Historic District Approval Application

800 McDonald Avenue 95404, Santa Rosa
Completed building 1983
Original Owner/Architect-Gary Jensen; owner until death October 2016
Purchased by Broker/Seller: Bruce and Cindy Tonacasia (2016)
Purchased by Mary Patricia O’Day/John Grabowski (July 2017)

Request for:

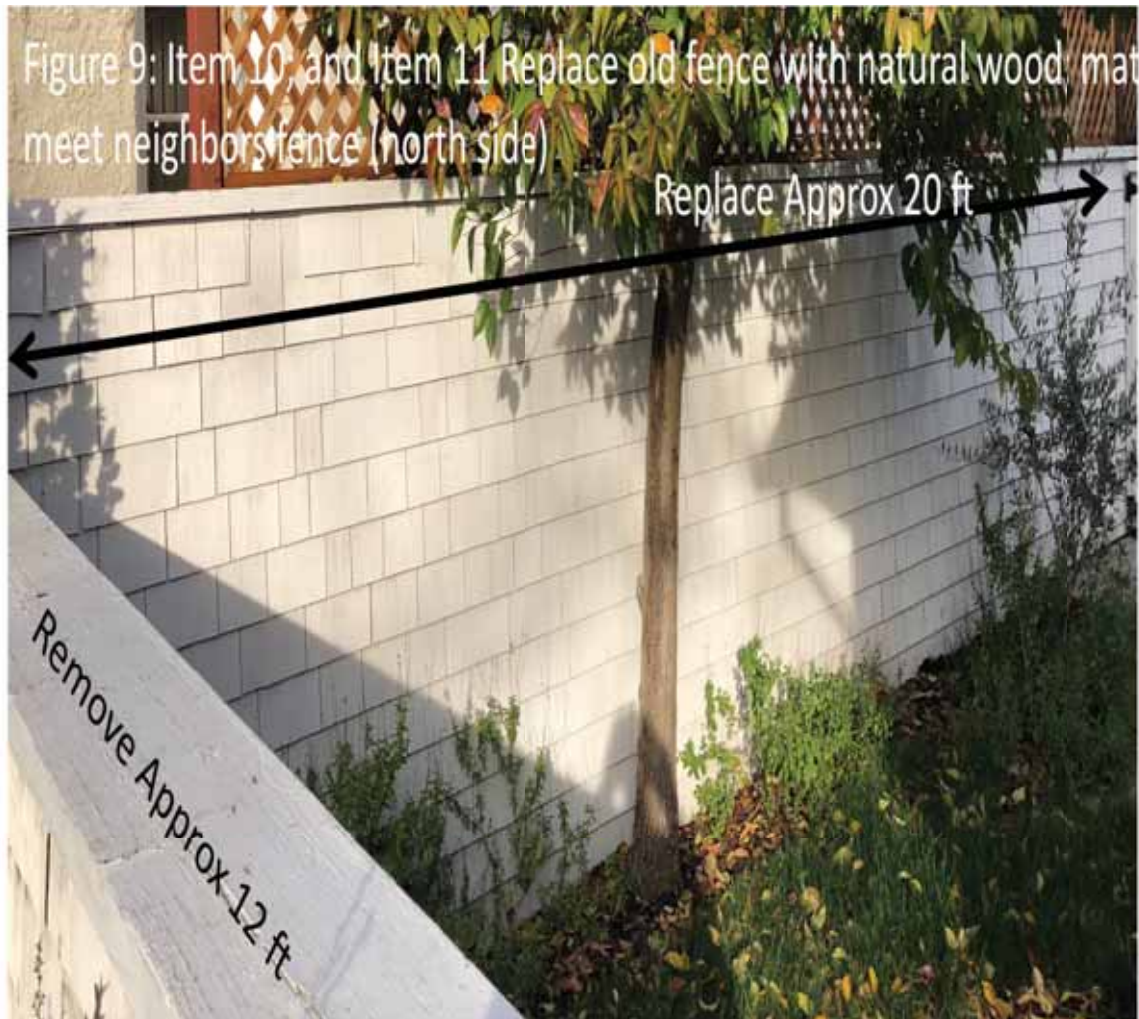
1. Fence, previously natural wood but painted white prior to our purchase (approx. 65 feet, south, side, 13th street) was vine covered. Removal of vines indicated they had been “structural support” and fence was collapsing. We replaced with a natural fence installed by Redwood Residential Fencing, Santa Rosa CA. Same configuration (13th street with wrap to garage at rear) as original and similar to other side fences on street. **(Figure 7)**

Schematic A
Changes
requiring
Legalization
notations jg

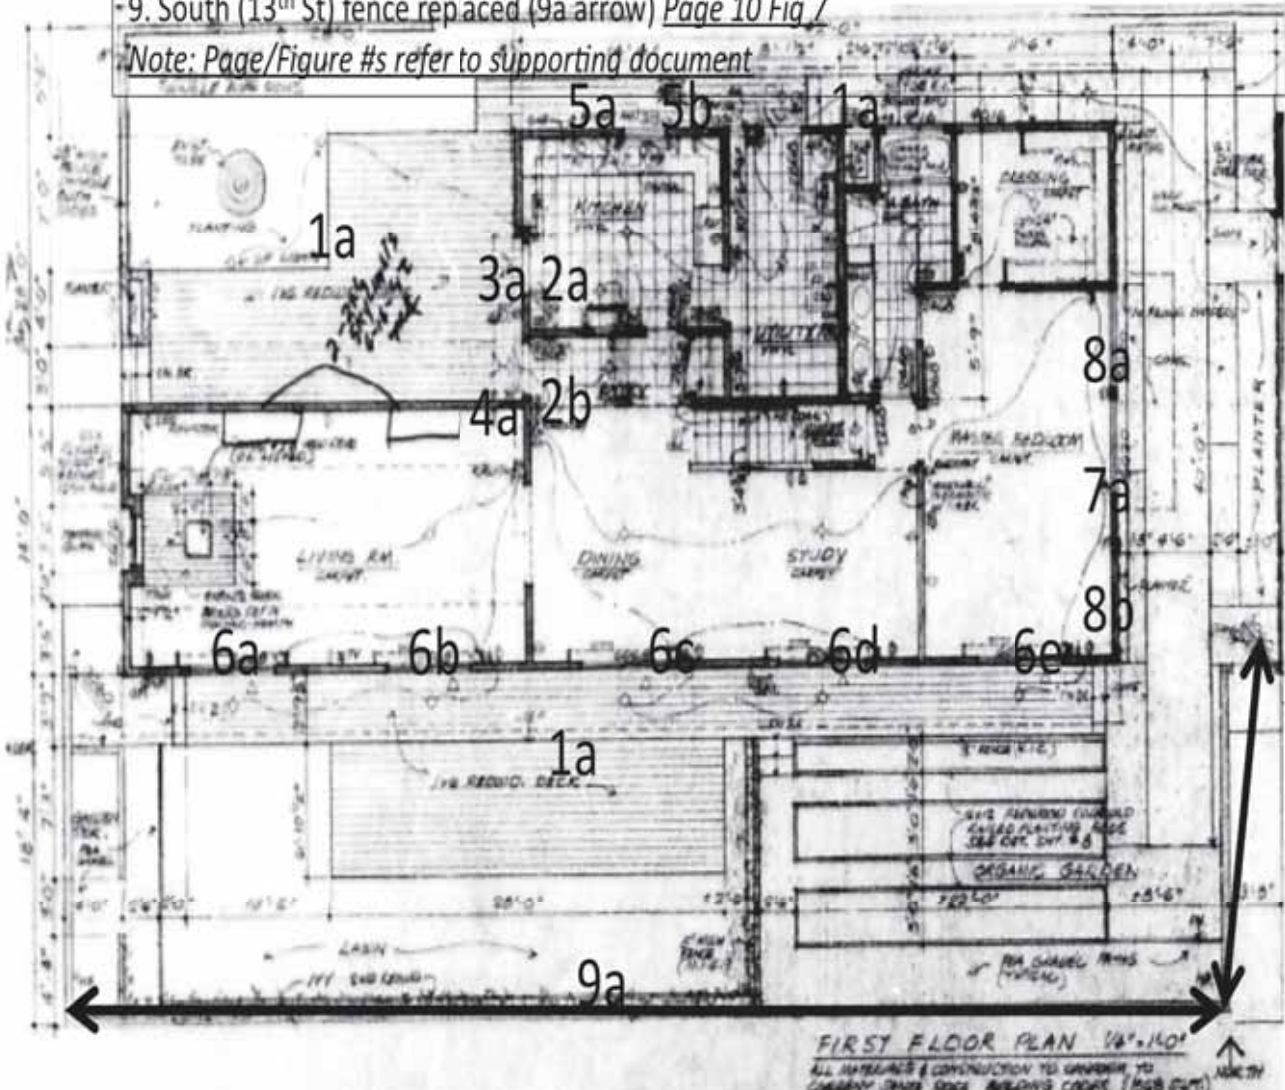
1. Redwood decking replaced with concrete (1a), Page 5, Fig 2, also Page 7, Fig 4
2. Two front doors removed (2a, 2b), Page 5, Fig 2
3. Window at kitchen replaced one door (W57in x H21 in) (3a) Page 5, Fig 2
4. Entry door installed at right front (W36 in x H 80 in) (4a) Page 5, Fig 2
5. North kitchen window removed (5a), laundry window replaced (5b) Page 6, Fig3
6. Sliding glass doors (south) replaced/double doors (W70 in x H78) (6 a-e) Page 7, Fig 4
7. Center (east) window removed (7a) Page 8, Fig 5 #1
8. Two windows (east) installed(W33 in x H57in) (8a, 8b), left and right Page 8, Fig 5 #2
9. South (13th St) fence replaced (9a arrow) Page 10 Fig 7

Schematic B (notations jg)

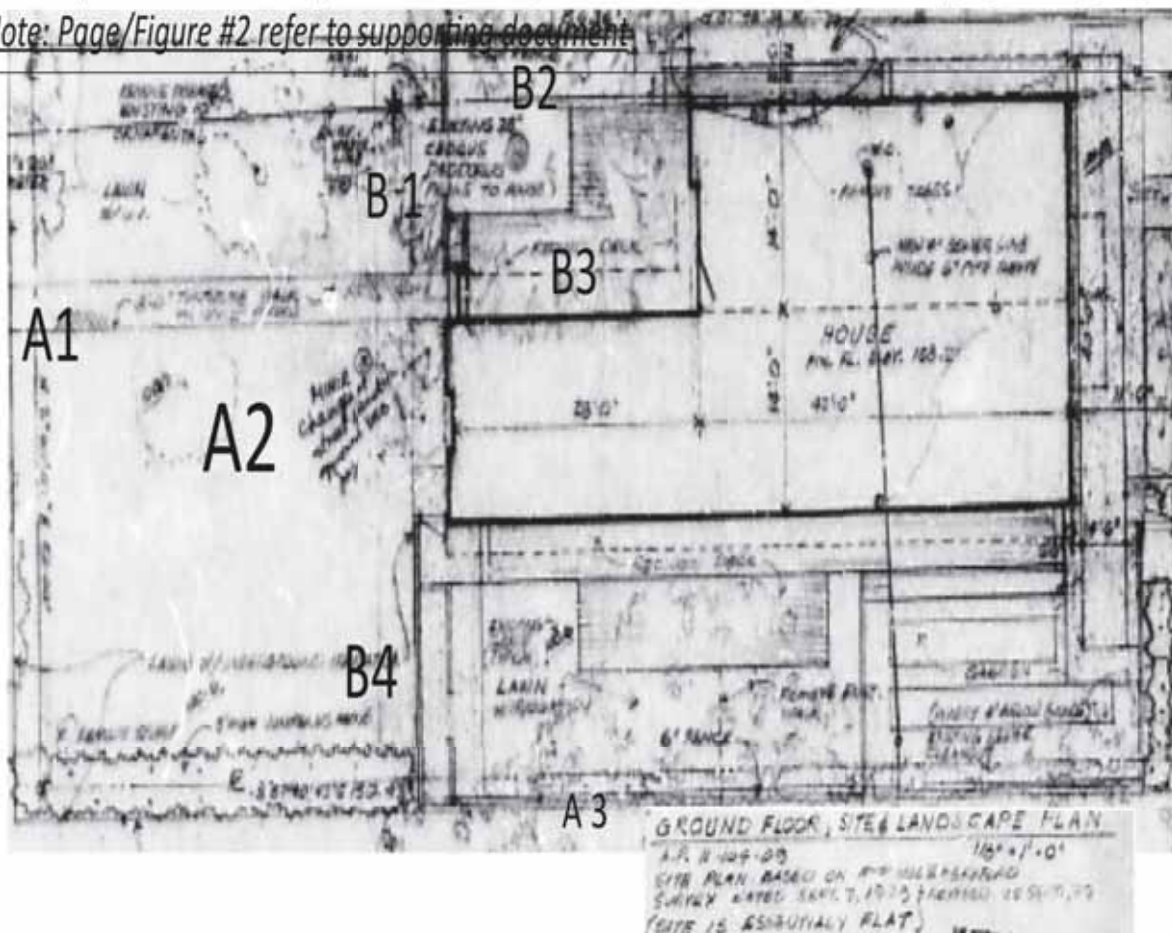
A. Changes requiring legalization

1. Gate appearance change Page 9 Fig 6
2. Indeterminate plant changes front yard; to be re landscaped (plan attached)
3. South facing fence replaced (13th St), Page 10 Fig 7

B. Approval requested (new)

1. Remove west facing set back half fence Page 11, Fig 8a/b
2. Replace 20 ft north facing fence to match neighbors Page 11, 12, Fig 8, 9
3. Install low water feature and bench Page 13, Fig 10
4. Replace fence and adjacent shed wall (to match north and south fence) Page 14 Fig 11

Front McDonald Original and Current Elevation (except #7)

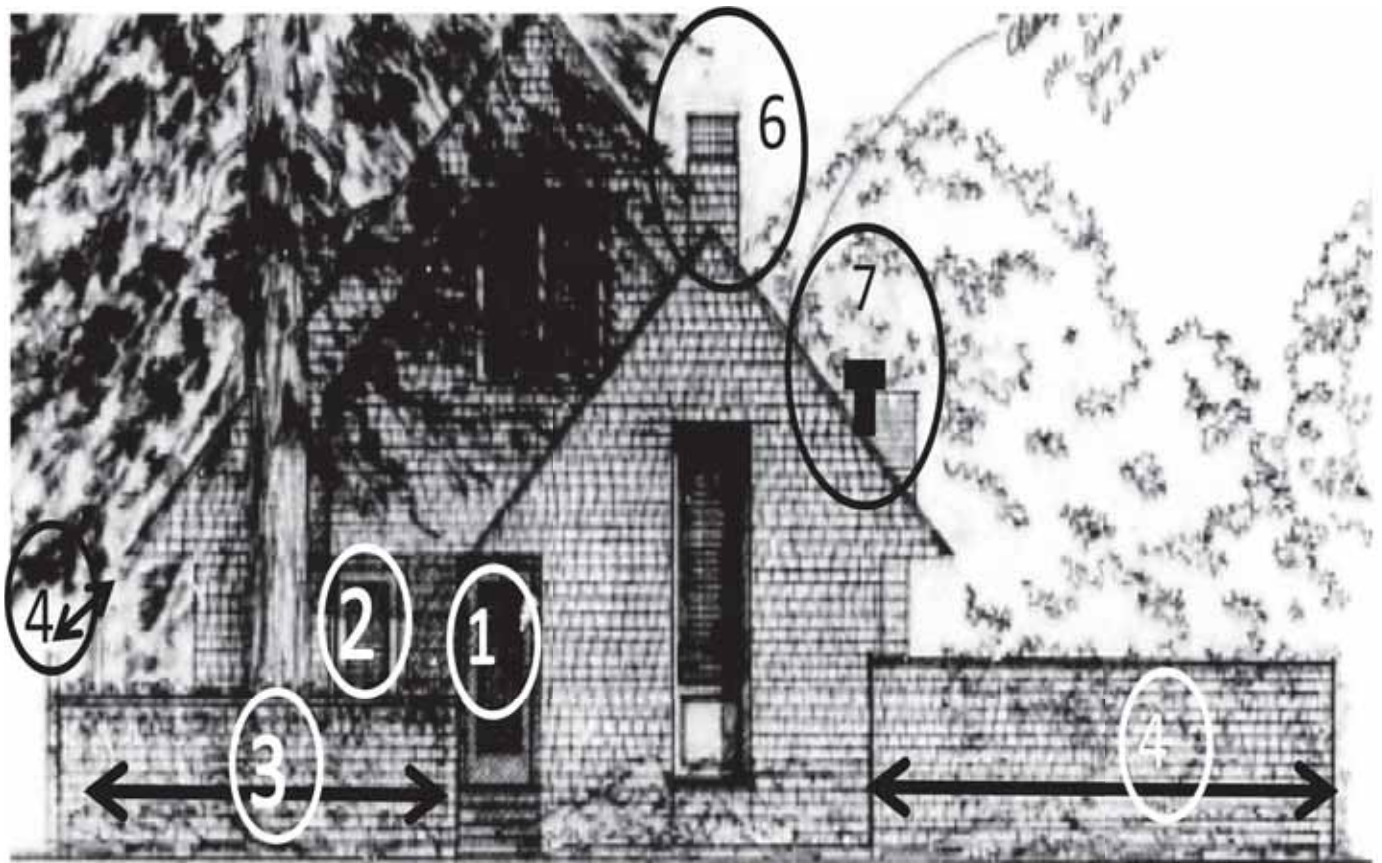
1. Front door removed, moved to right, facing north
2. Window installed, facing east
3. Left: Remove east facing set back half fence; *Figures 8 and 10, Pages 10 and 12*
4. Left (not visible): Replace north facing fence from half fence to junction with neighbors equivalent redwood fence; *Figure 9, Page 11*
5. Right: Replace half fence and shed facing with natural redwood (will adjoin redwood fence on south (13th Street); *Figure 11, Page 13*
6. Chimney removed in renovation; *Figure 1, Page 3*
7. Chimney current location (set back ~15 ft); *Figure 4, Page 6*

800 Mc Donald Original and Change North elevation

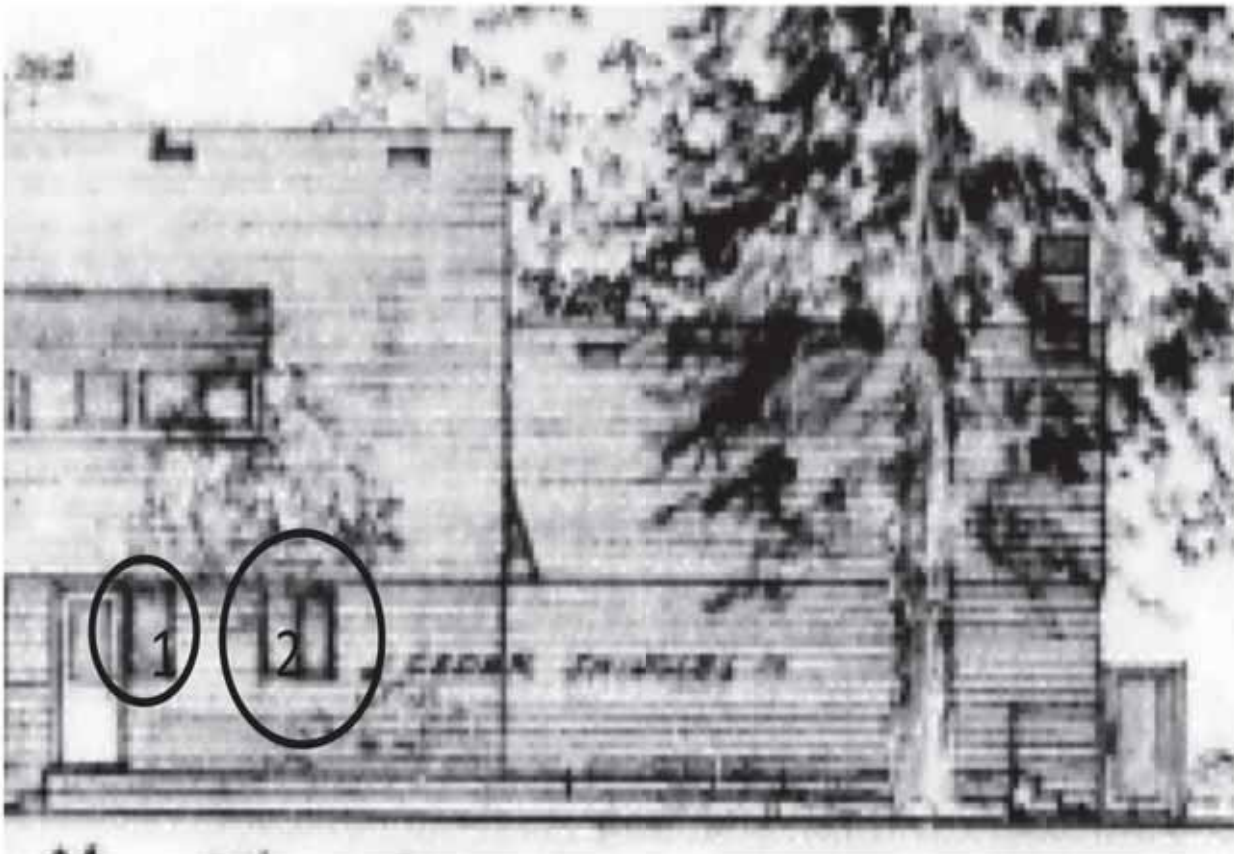
1. Laundry room window replaced
2. Kitchen window removed

800 Mc Donald Original and Current South Facing Elevation

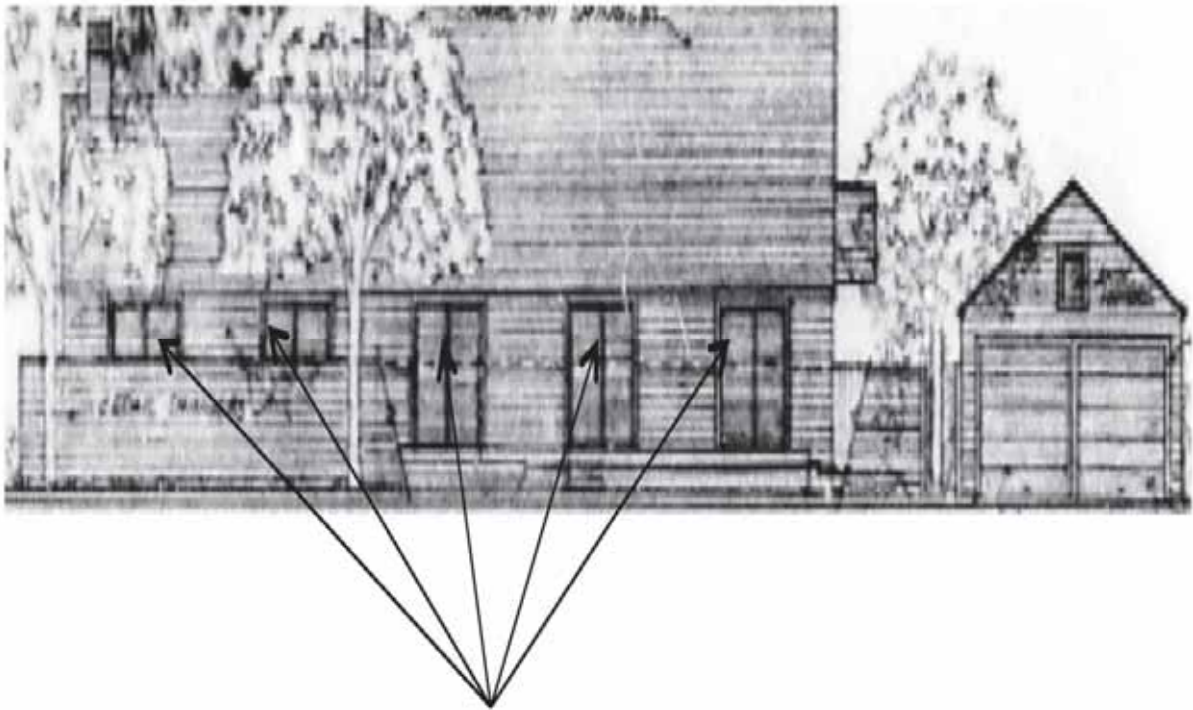
Sliding glass doors replaced with double open doors ("French Doors")
(at arrows)

800 Mc Donald Original and Change East Facing Elevation

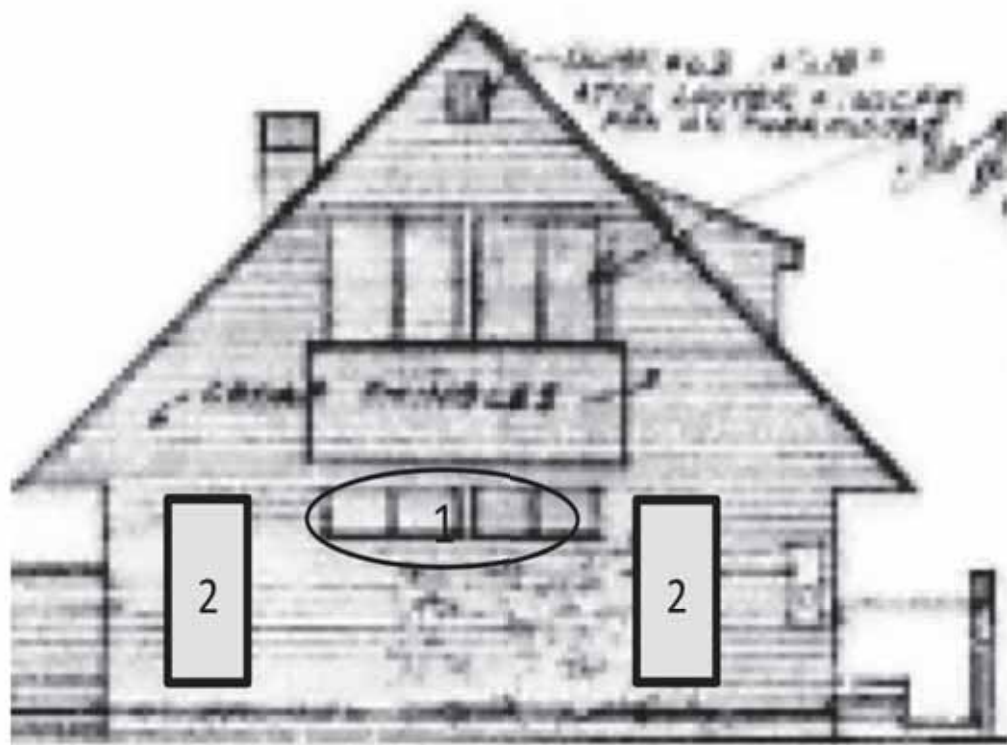
1. Windows removed--oval
2. Windows installed
